Engineering Technical Assessment of Maintenance, Operating and Capital Expenditure Forecast in Aurizon Network's Draft 2013 Access Undertaking

QUEENSLAND COMPETITION AUTHORITY

Response to Stakeholder Submissions

8 April 2014

Figure 1: Updated unit cost (\$ / gtk) - CQCR

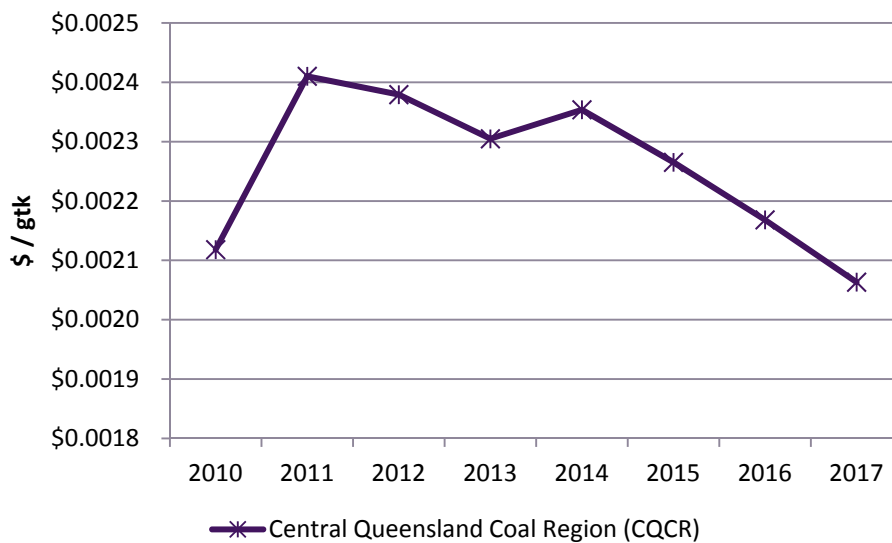
The QRC requested that Jacobs SKM determine if Return on Assets (ROA), internal margins and corporate overheads were included in the UT3 historical cost base and remove if required.

The revised unit cost of maintenance is depicted in **Figure 1**. On average, when adjusting for the issues outlined above, the unit cost for the UT4 period is still lower than the UT3 period, although the quantum of reduction over UT3 costs is far less pronounced than previously reported (the average unit cost for the UT3 period was \$0.0023 per gtk compared to \$0.0022 forecast for the UT4 period, which is 4 per cent lower on average).

Jacobs SKM welcomes the opportunity to provide updated cost estimates which address the issue noted by the QRC.

Jacobs SKM issued Requests for Information (RFI) to Aurizon Network seeking historical costs for the purposes of benchmarking. To the best of Jacobs SKM's knowledge at the time, these costs were comparable. However, Jacobs SKM has since received confirmation from Aurizon Network that the historical expenditure estimates which Jacobs SKM used in the analysis are inclusive of ROA, internal margins and corporate overheads, whereas the project forecast costs aren't.

Figure 3: Normalised maintenance costs – total absolute dollars

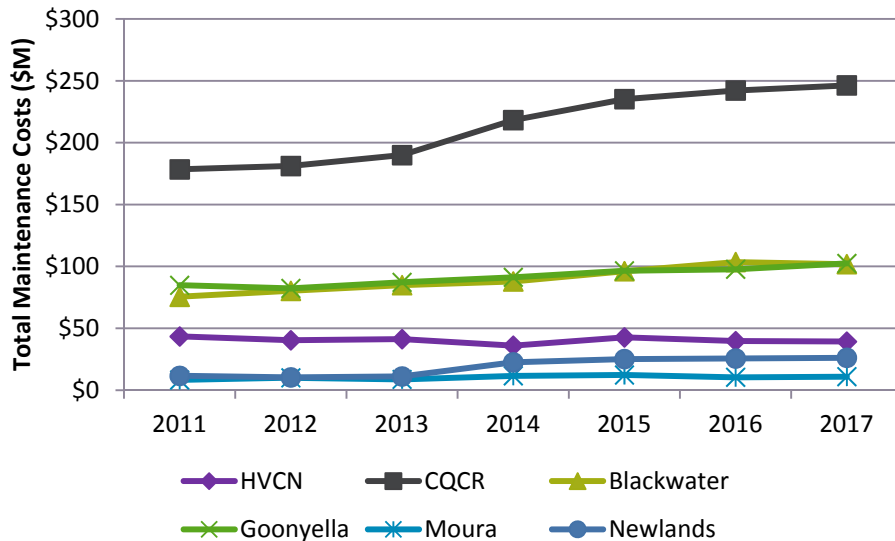
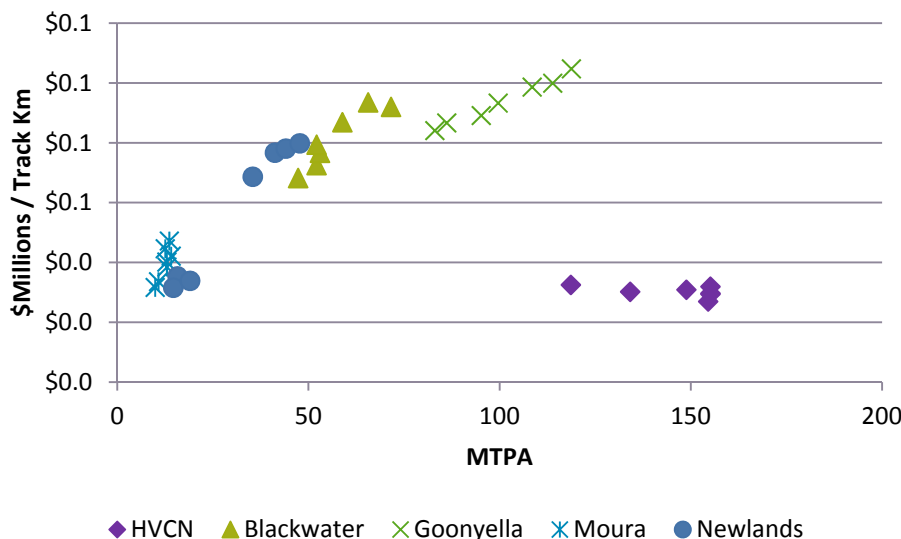
- *The QRC raised concerns about the time period of benchmarking data referred to in Jacobs SKM's report.*
- *The QRC raised concern about the zones included in the Hunter Valley Network forecast costs, requesting that more detail is provided. Specifically, the QRC was concerned that maintenance costs for Zones 1 -3 were utilised while track kilometres for Zone 1 only were utilised.*
- *The QRC raised concern that Jacobs SKM inadvertently utilised costs for the entire CQCN as representative of the Blackwater system, and that costs for the Blackwater system should not be greater than the total cost for the CQCN.*
- *The QRC raised concern about Jacobs SKM's conclusions from the benchmarking exercise and suggested that more information about differences between the HVCN and the CQCN should be outlined, including the impact on costs.*

Updates to Figure 2.14 and Figure 2.16 of Attachment C in Jacobs SKM’s report are provided in **Figure 3** and **Figure 4** below. This update considers changes to track kilometres and costs for the Blackwater system. In addition, the historical UT3 costs have been adjusted to remove ROA, corporate overheads and internal margins.

Figure 5: Normalised unit cost of maintenance including regional uplift factor and network size uplift factor - \$millions / track km compared to MTPA

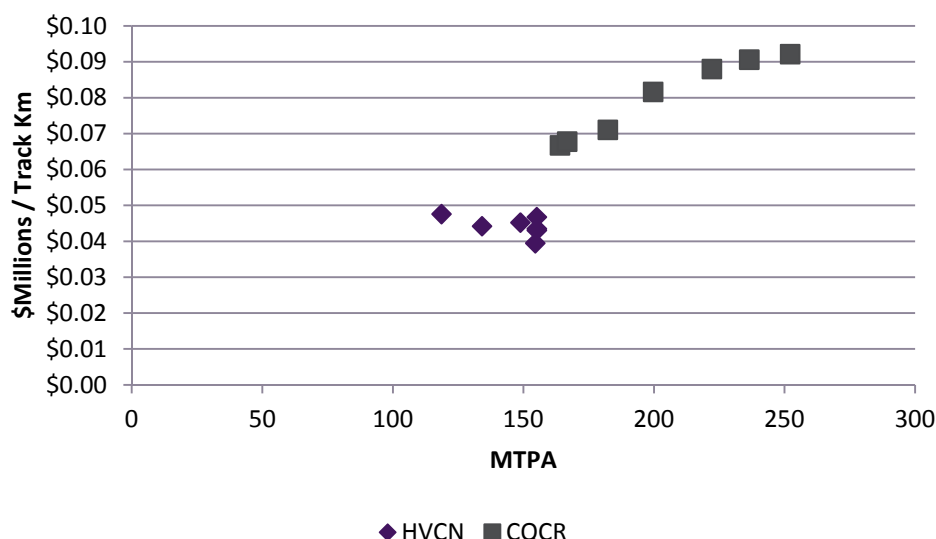
The combined uplift factor for regional price pressures and network size is 146.45⁸ and is applied to the HVCN maintenance costs. **Figure 5** provides the revised costs taking into account the above. On average, after normalisation, maintenance costs for the CQCR are approximately 30 per cent higher than the HVCN. Jacobs SKM finds that this differential is reasonable on the basis of other contributing factors such as the opportunity for cost sharing of routine maintenance tasks between coal and non-coal traffic on the HVCN. It would not be

reasonable to suggest that the normalisation exercise would take account of all nuances between the networks, and, as such, Jacobs SKM considers that this variation in costs between the two networks is to be expected given the overall differences between the network and therefore is reasonable.

Figure 7: Network ballast undercutting - UT3 actual scope compared to UT4 forecast scope

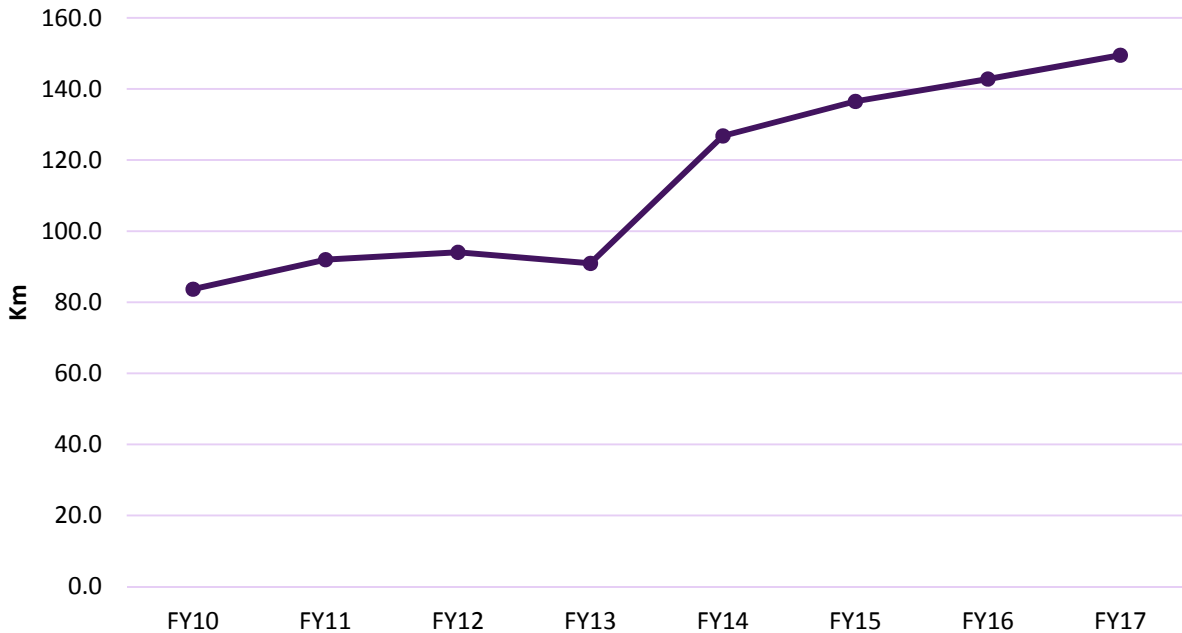
The QRC queried what additional costs are being forecast in 2013/14 to drive the 34% (excluding corporate overheads and ROA) increase in costs from 2012/13.

The increase in costs for FY14 is largely attributable to an increased scope of ballast undercutting compared to FY13. **Figure 7** provides the network ballast undercutting for the UT4 period compared to the actuals for the UT3 period.

Figure 8: Mainline ballast undercutting unit cost - Actual (UT3) compared to forecast (UT4)

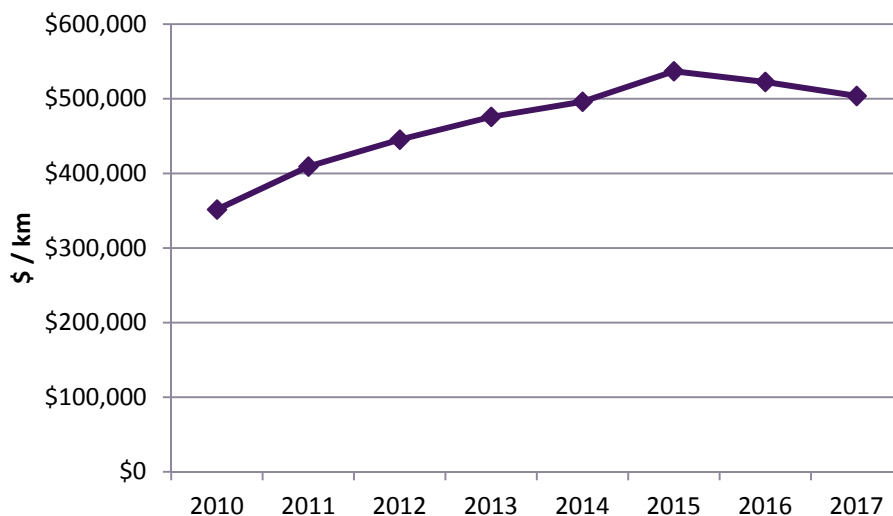
Figure 8 shows the unit cost of the network ballast undercutting task in \$2012, which was developed by Jacobs SKM from information provided by the Authority for the historical scope review. A revised unit cost was provided by Aurizon Network on the 28 March 2014 in \$2011 which shows the same trends.

Figure 8 shows that although the cost increase for ballast undercutting is largely due to scope increases, some of the cost increase is also attributable to an increase in the unit cost for the UT4 period.

Jacobs SKM requested additional information from Aurizon Network to justify this increase in unit cost, which was provided on the 28 March 2014. The following summarises Aurizon Network’s response, and Jacobs SKM

considers that they provide a reasonable justification for unit cost increases. However, Jacobs SKM considers that this trend should not continue, particularly since the scope should not increase significantly in the next regulatory period¹⁰:

- the increase in unit costs between FY13 and FY14 is attributable to:
 - a significant increase in scope which necessitates a step change in resourcing required, including introduction of the off-track cleaning solution (which has a higher unit cost than the RM900) for areas which are not suited to the RM900;

- increasing maintenance costs for the RM900 which is now 14 years old.
- in FY15, the increasing unit cost is largely attributable to the increase in depreciation and plant maintenance costs for the new assets (24 new spoil wagons and 56 upgraded ballast wagons). In addition, the forecast assumes that it will take time to get the new expanded operation to full operating capacity.
